# Redfern–Waterloo Draft Built Environment Plan 2 [BEP2]

Submission to the Redfern-Waterloo Authority 11 April 2011

**CITY OF SYDNEY**   
*city of villages*

Figure 21 Possible neighbourhood park location

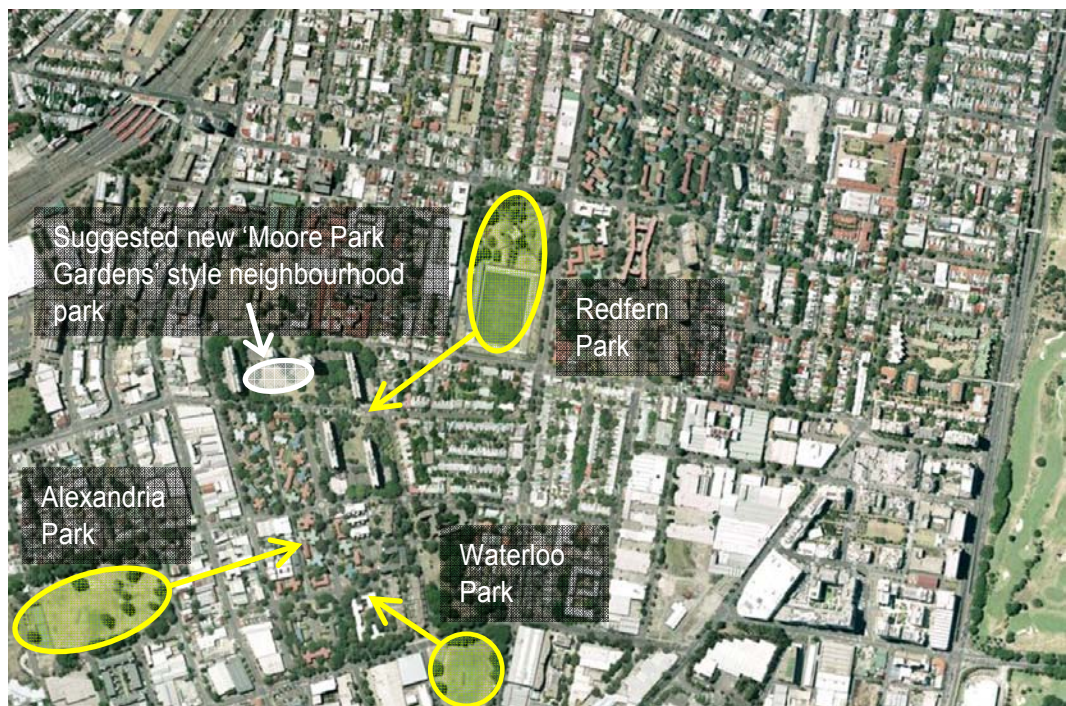
If any new publicly accessible neighbourhood park is created, consideration should be given to redefining a large green space in Block 10 (Figure 21).

Figure 31. Proposed Zonings, draft BEP 2 January 2011.

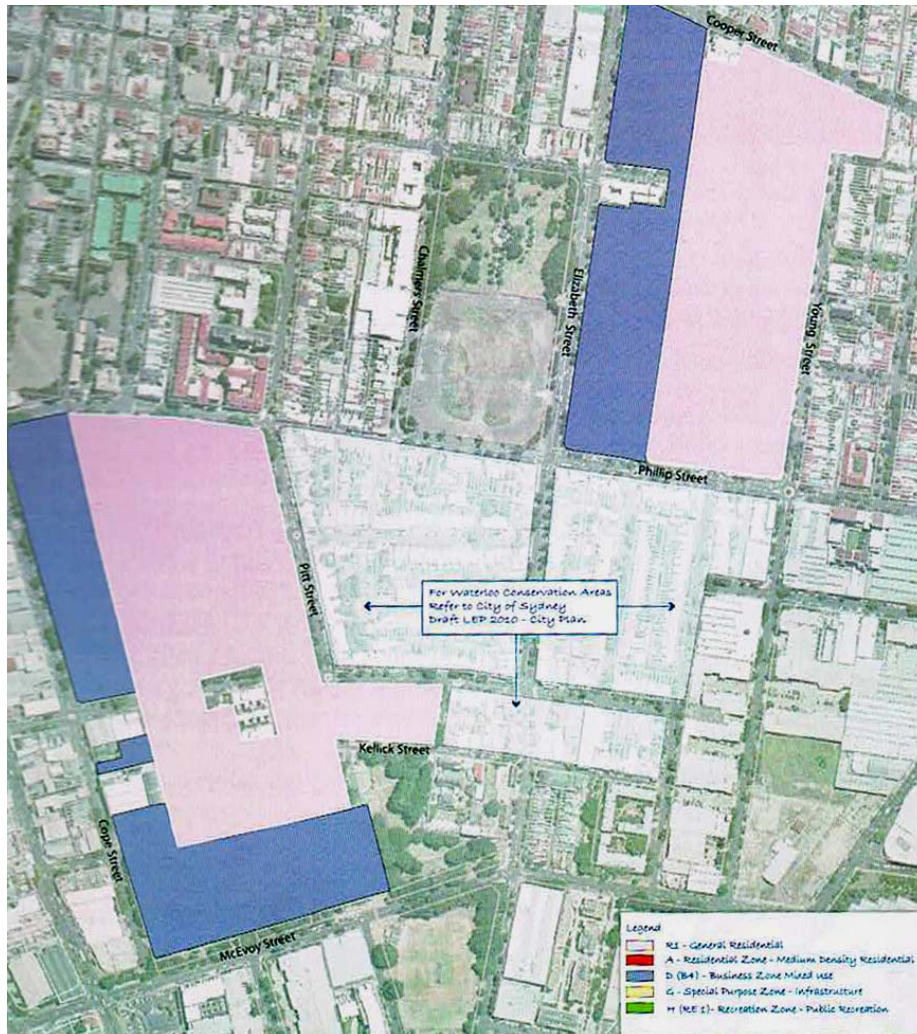
In principle, the proposed land use zones of B4 along Elizabeth Street in Redfern and Cope Street in Waterloo (Figure 31) is not objected to, although the proposed controls exclude non-residential uses from the maximum FSR controls which is not supported and is not contemplated by the draft LEP template. The General Residential zone R1 elsewhere is generally supported.

Figure 34. Sample Block 5 design by RWA superimposed on aerial photo (number of floors indicated)

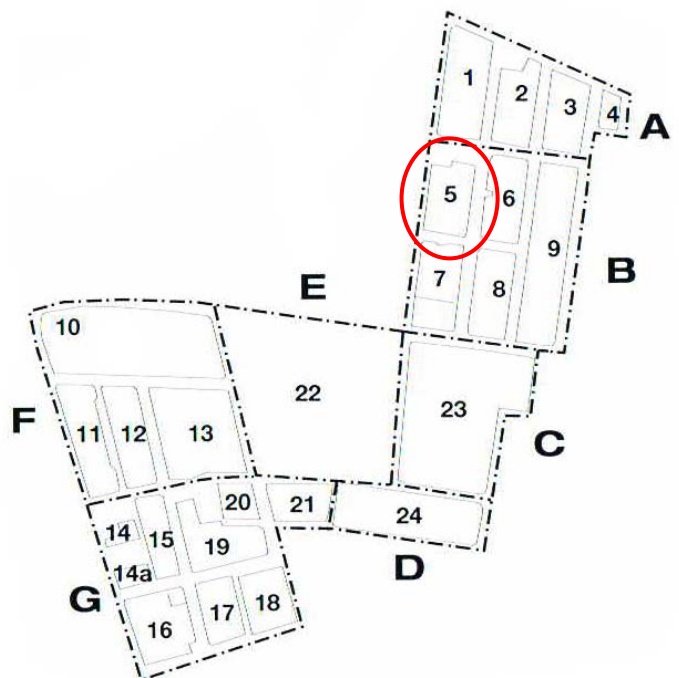
### Comment

A 4 metre setback (for street tree canopies) and occasional specific major tree setback, results in an FSR of 2.65:1 at the draft BEP 2 proposed heights which is a reduction of 11%. However, due to the location along Elizabeth Street, it may be possible to test the Elizabeth Street heights at 10 storeys (parapet at nine storeys, 10<sup>th</sup> storey setback 3m) and 8 storeys along Morehead Street (parapet at 7 storeys, 8<sup>th</sup> storey setback 3m). This results in an FSR of 3.09 (with FSR of .09:1 dedicated to ground floor commercial use).

Figure 38. Sample Block 12 design by RWA superimposed on aerial photo (number of floors indicated)

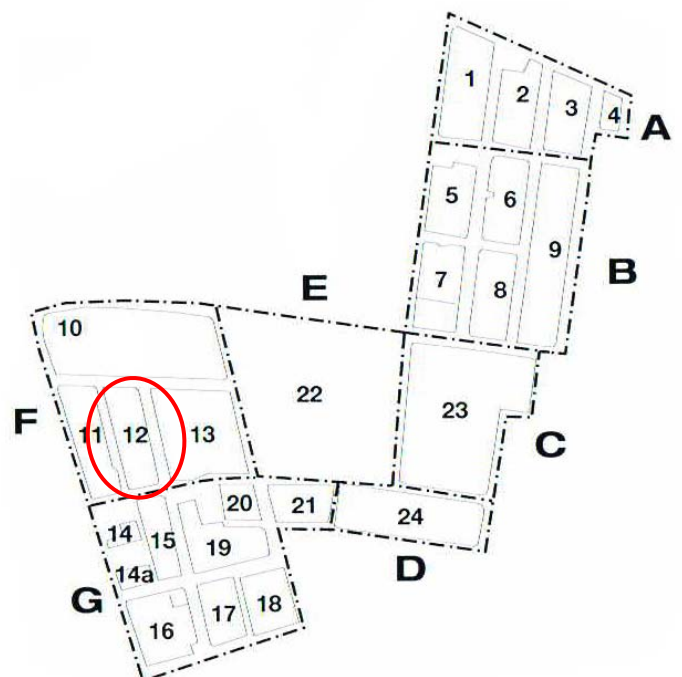
### Comment

Block 11 and 12 is one of the few locations which may be able to take more height following detailed testing during the master plan stage. Any increase in height must absorb the reduction in height and FSR at the more sensitive sites in Redfern and Waterloo. The more sensitive sites are: Blocks 1, 2, 3, 4, 6, 7, 16, 17, and 21. An increase in FSR to 4:1 for Blocks 11 and 12 would produce a similar result to Moore Park Gardens (MPG) if it is assumed that the area of open space (or park) at MPG is provided on Block 10 as shown in Figure 40.

Figure 43. Sample Block 16 design by RWA superimposed on aerial photo (number of floors indicated)

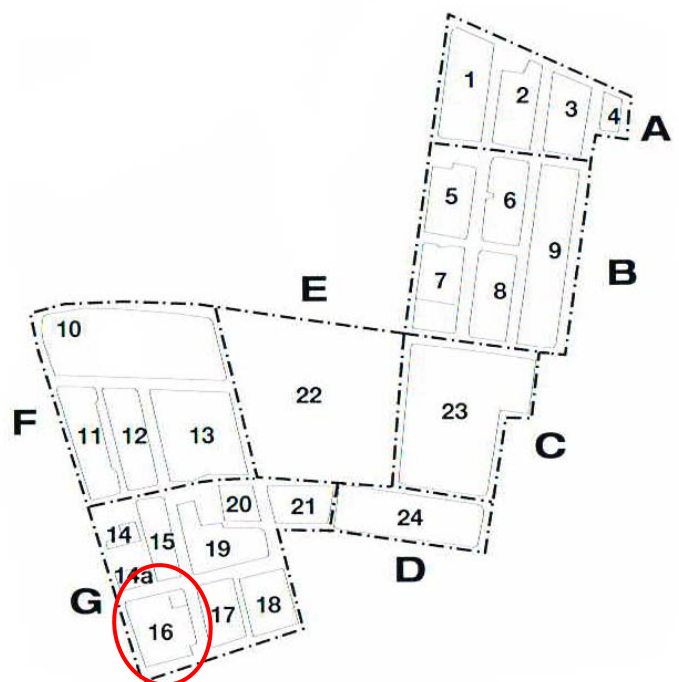
*The proposed height and bulk on this Block is generally supported however the existing green canopy is not integrated. More site specific building designs and footprints with setbacks are required which will result in somewhat reduced FSRs (see Figure 45).*

With the setbacks adjusted to retain the key trees, the FSR at the draft BEP 2 heights is 2.25:1.
